REMARKS

Amendments to the drawings**In the Drawings:**

FIG. 1

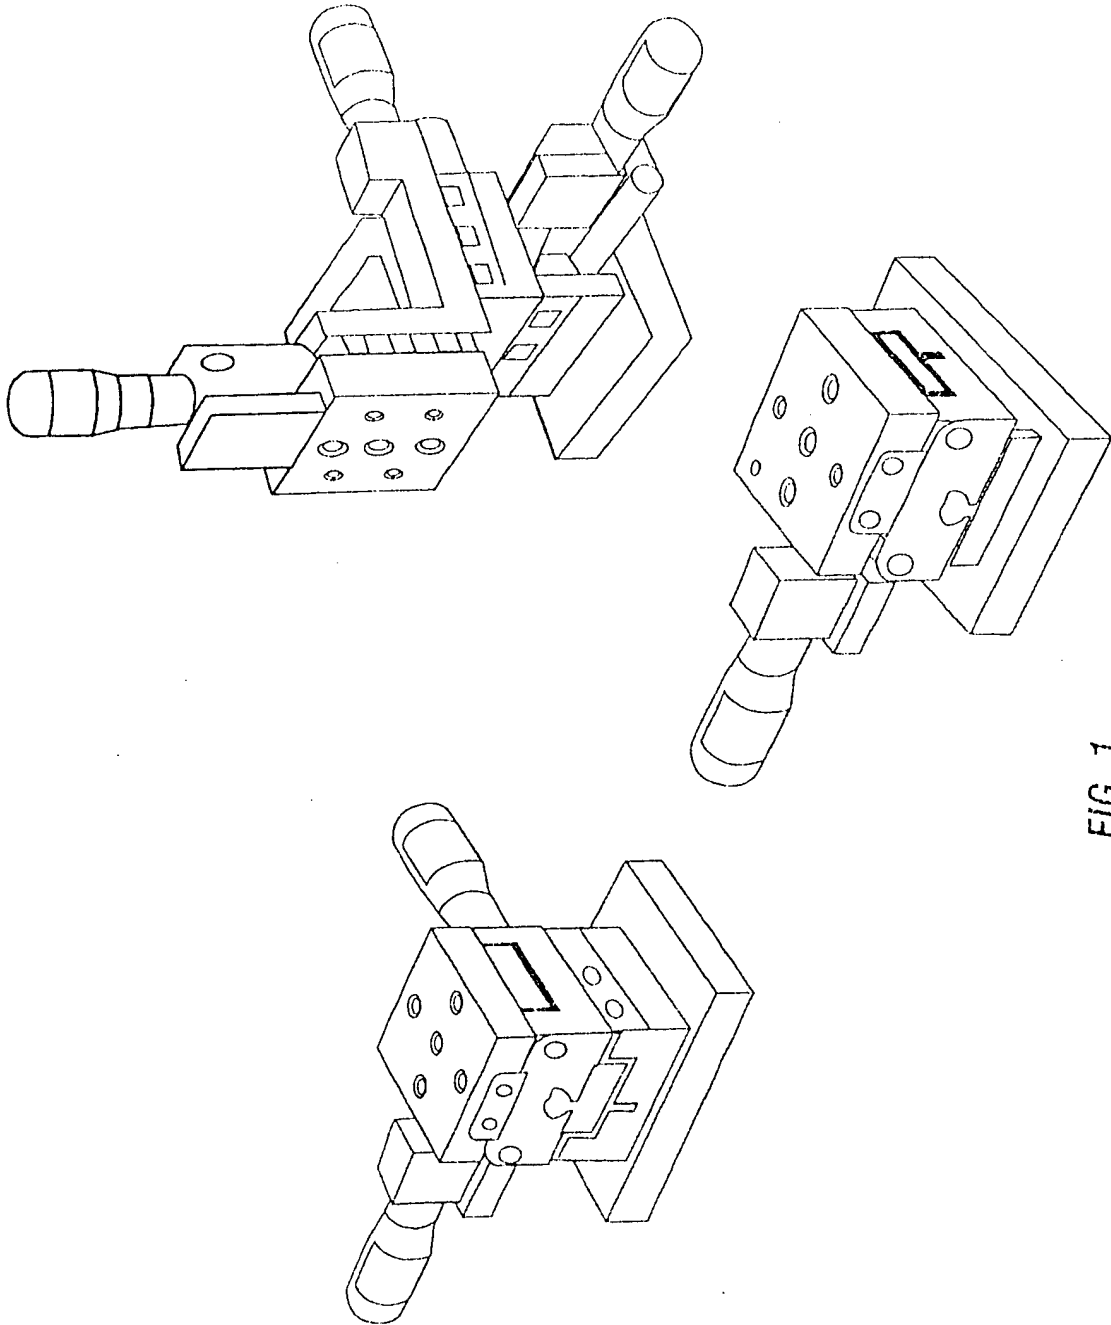
We respectfully ask entry of the proposed amended versions of FIG. 1-4 enclosed herewith. As filed, FIG. 1-3 inadvertently failed to include the text “(Prior art)” and FIG. 4 inadvertently failed to include the text “(Background art).” These amendments will bring the figures into conformity with the text in paragraphs [0014]-[0017] of the specification.

Added

Proposed amendments to FIG. 1-4 and 7 are provided herewith. Enclosed are 5 sheets of Annotated Mark-Up Drawings and 5 sheets of clean as-amended Replacement Sheets, wherein FIG. 1-3 have the text “(Prior art)” added, FIG. 4 has the text “(Background art)” added, and FIG. 7 has the reference 20 replaced with the reference 68.

FIG. 2

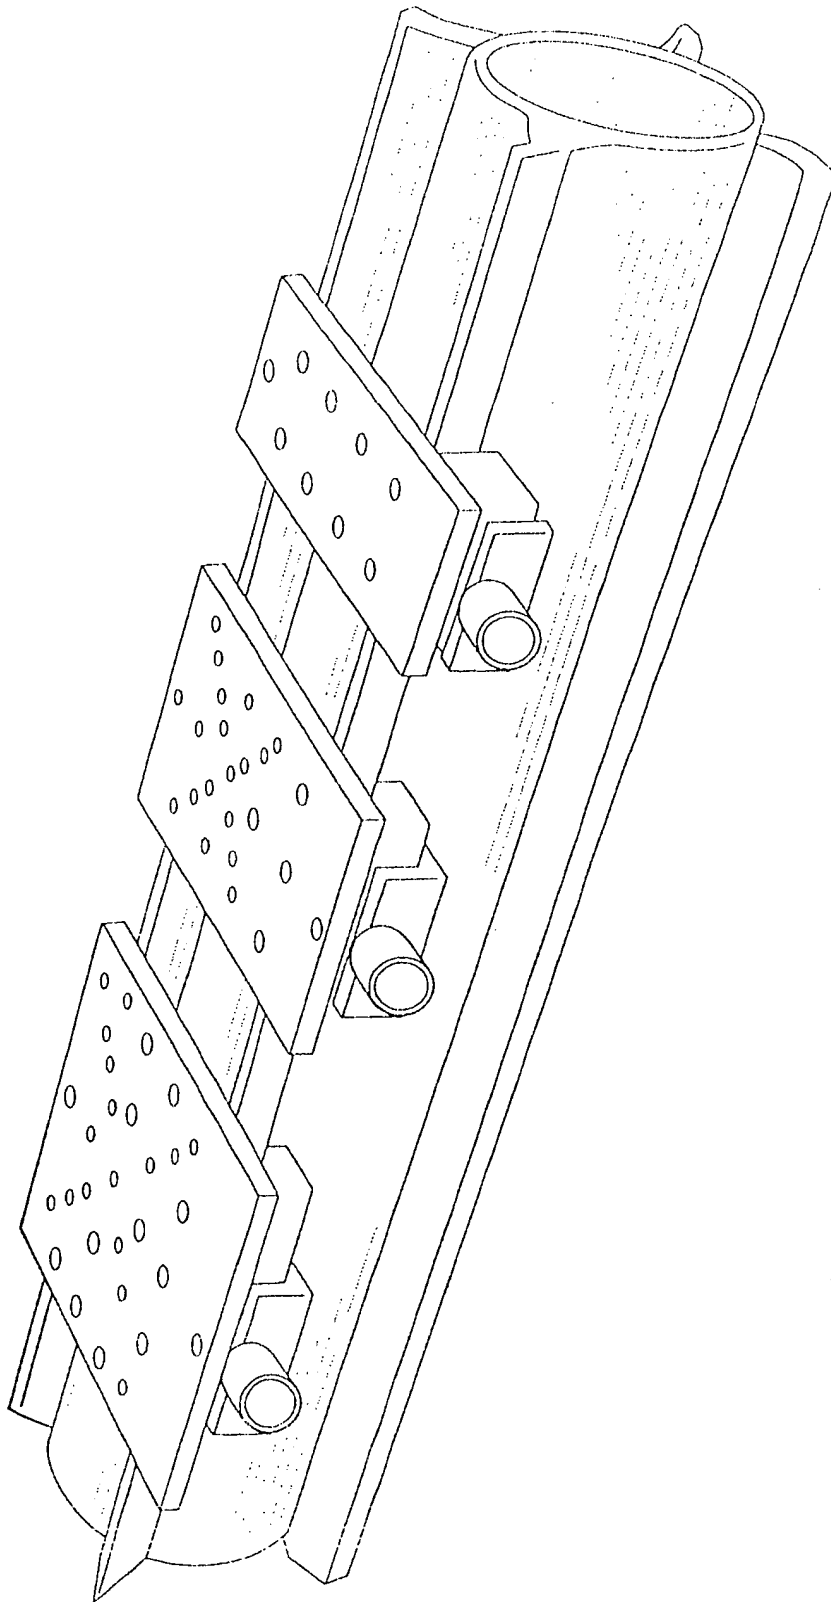
Turning now to claim 4, it recites “*a plurality of said stages and at least two said stages include a same said first piece and share a same said digital scale.*” FIG. 2 (Prior art) clearly shows multiple stages sharing a mount, thus the mechanical aspects here would be understood by one of ordinary skill in the art. FIG. 5a-b, 6 and 7 show a digital scale, thus it would be understood by one of ordinary skill in the art what a “*same said digital scale*” is. And we further note that 37 CFR 1.83(a) does not require that drawings odiously show every possible straightforward variation feature of an invention, rather this states that “*applicant ... is required to furnish a drawing ... where necessary for the understanding of the subject matter sought to be patented.*” Respectfully, we urge that Applicant has shown what is necessary for one of ordinary skill in the art to understand claim 4.

Added

FIG. 3

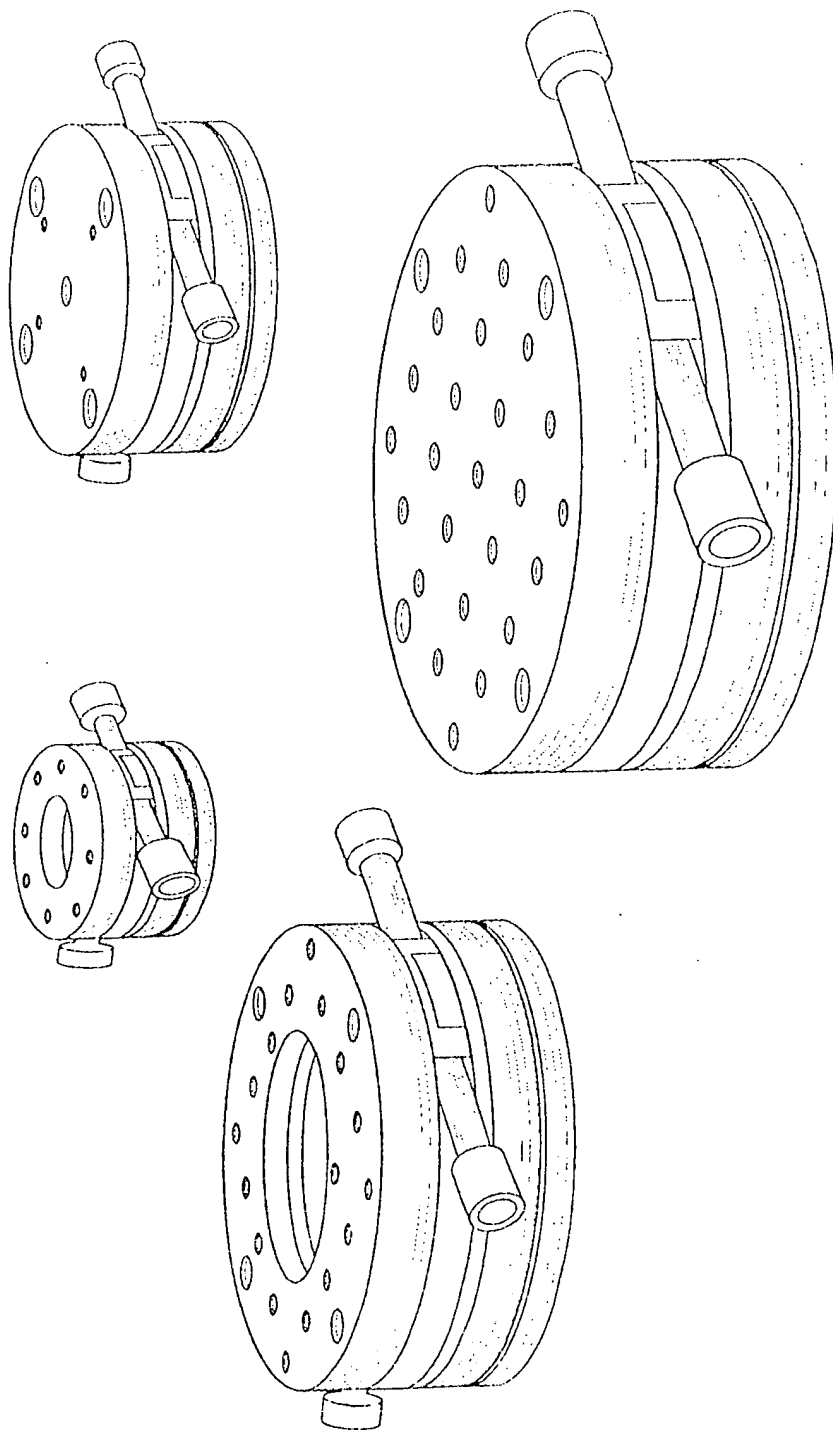
Added

FIG. 4
Rotary stage with mechanically engraved scale
(Background art)

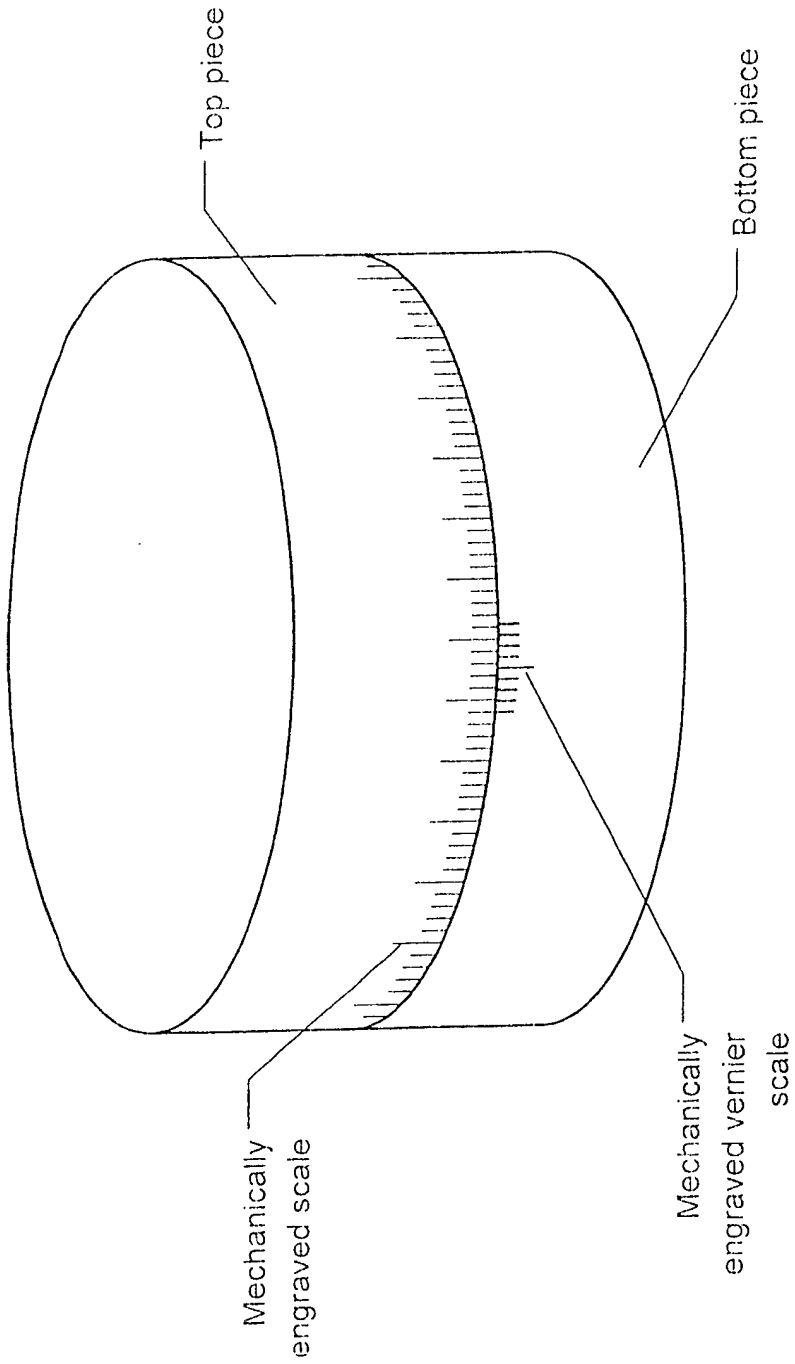
Added

FIG. 7
Rotary stage equipped with digital scale disk

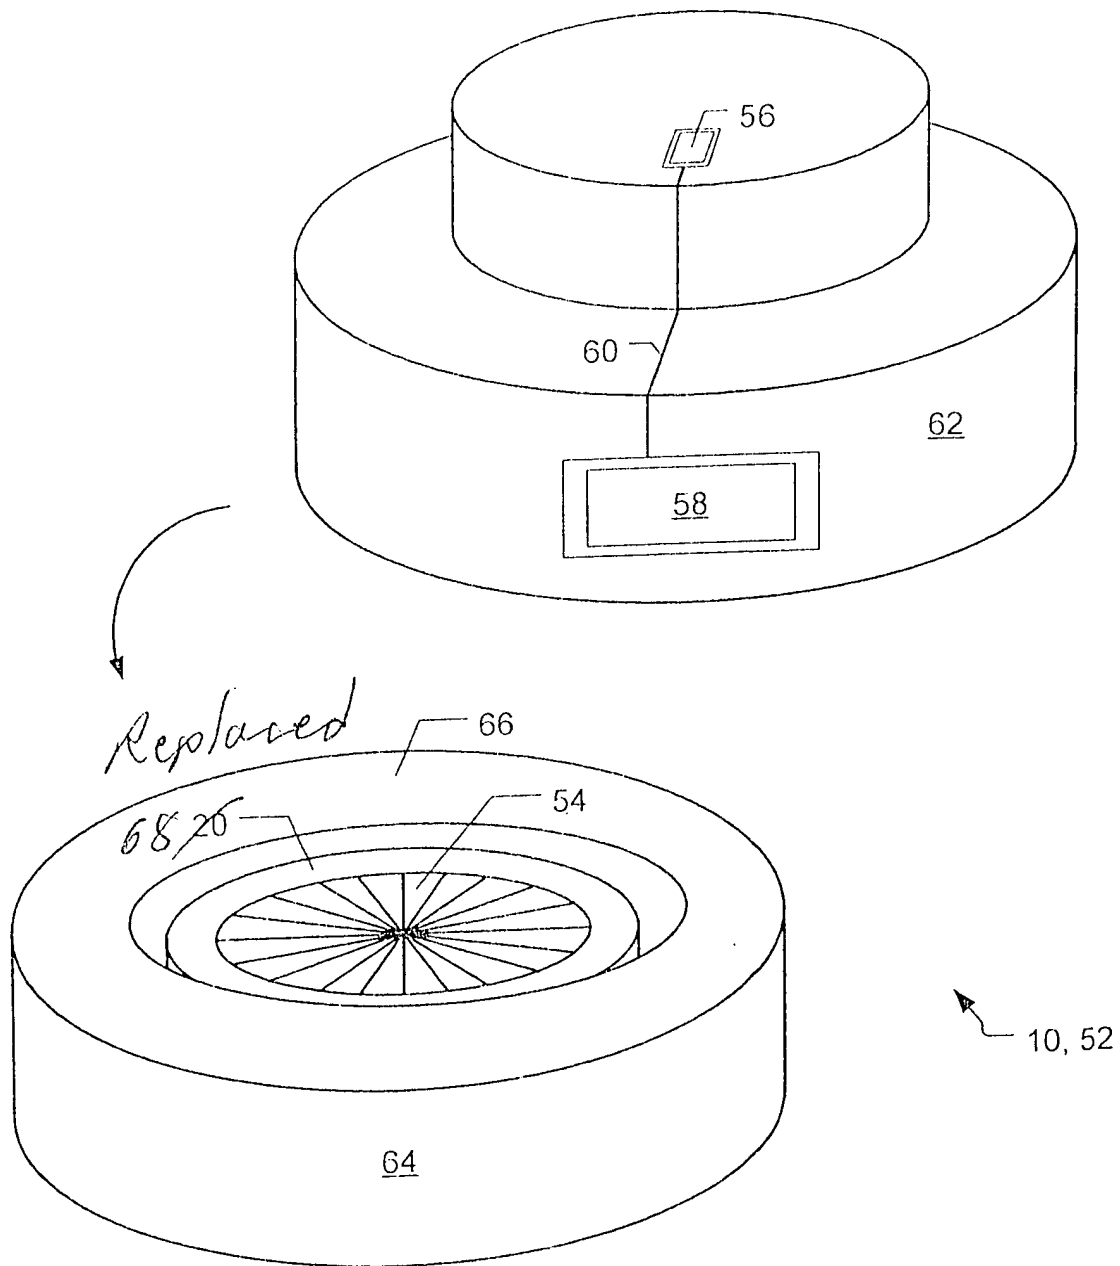
The Action here states, “*The drawings are objected to ... because they do not include the following reference sign(s) mentioned in the description: “68”*” This objection is well founded and corrective amendment is made herein.
